CITY OF HUNTINGTON BEACH REQUEST FOR CITY COUNCIL ACTION

SUBJECT: APPROVE MITIGATED NEGATIVE DECLARATION NO. 03-08
(Good Shepherd Cemetery - Appeal)

Transmitted for your consideration is an appeal by the applicant, Mike Padian of Padian Team Consulting, of the Planning Commission's approval of Mitigated Negative Declaration No. 03-08. This application analyzes the potential environmental impacts associated with the proposed expansion of Good Shepherd Cemetery that includes the phased construction of a three-story mausoleum, a maintenance facility, one-story garden crypt buildings, and construction of perimeter fencing. Conditional Use Permit (CUP) No. 00-63 covers the proposed cemetery expansion.

EXHIBIT 1 – Original Design (Applicant)

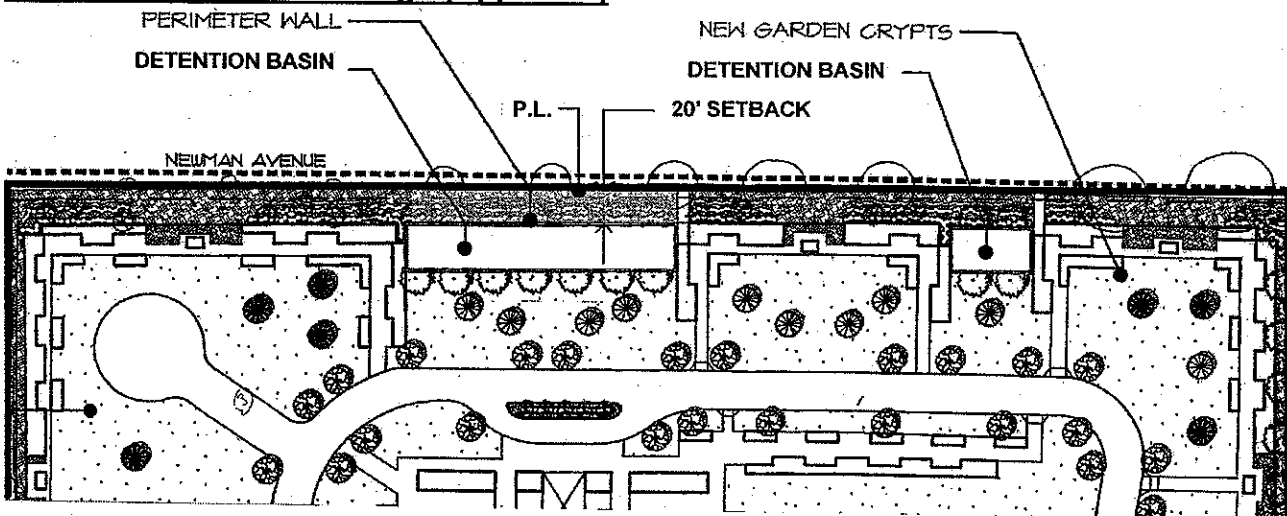
The applicant's original proposal to address the mitigation measure consisted of two detention basins with vertical concrete walls located in-line with the garden crypt buildings along Newman Avenue. The basins were surrounded by six-foot tall concrete block walls and were setback 20 feet from the northerly property line. The detention basins were approximately 206 ft. by 57 ft. and 61 ft. by 37 ft. respectively. Exhibit 1 below illustrates the original design of the detention basins:

The approved mitigation measure with the earthen slopes ensures that failing concrete walls, as proposed by the applicant, will not hinder future maintenance of the detention basins. The possible repair of the concrete walls could be difficult based on the location of the proposed improvements.

EXHIBIT 2 – Revised Design

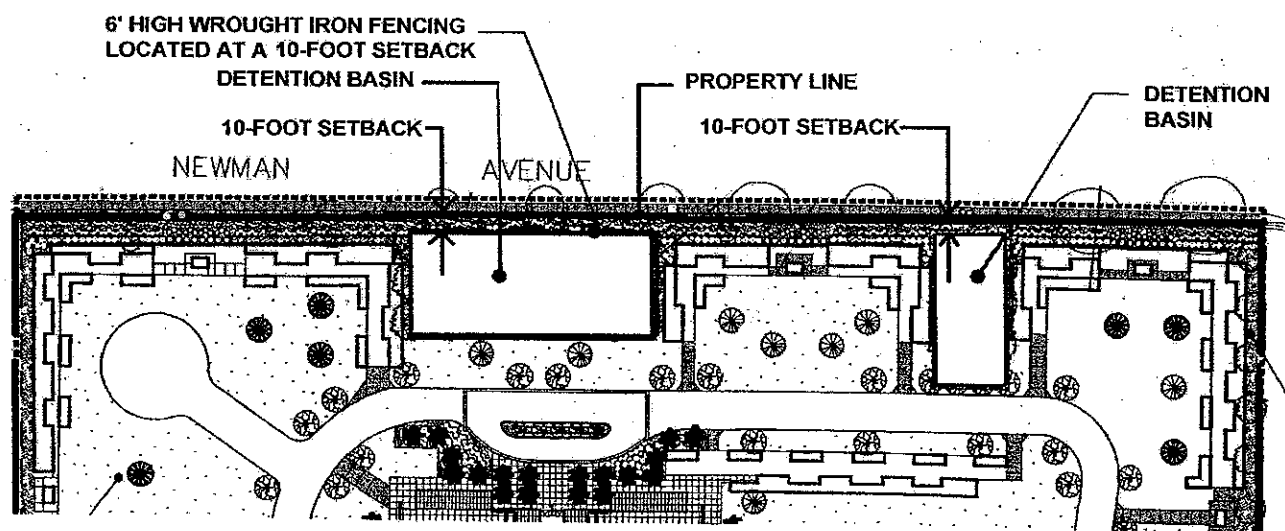
The revised proposal consists of two detention basins in approximately the same location but at a minimum code required setback of 10 feet in lieu of the originally proposed 20 feet. The detention basins have increased in size to accommodate the 2 to 1 earthen slopes. The basins now measure approximately 197 ft. by 90 ft. and 60 ft. by 132 ft. respectively. The depth of the basins range between approximately 6.5 feet to 6.7 feet. As a result of the depths of the basins, a six-foot high wrought iron fence is required around the perimeter of the detention basins in accordance with the Uniform Building Code. The following exhibit illustrates the revised design:

The bottoms of the detention basins will be planted with ground cover and the slopes will be landscaped with ground cover, low shrubbery, and trees. As shown in Exhibit 2, a perimeter wrought iron fence surrounds the detention basins.

Staff supports the revised mitigation measure based on the proposed design of the detention basins with earthen slopes. The revised mitigation measure is consistent with the findings of the MND and the CUP and will provide a compatible and aesthetic design solution consisting
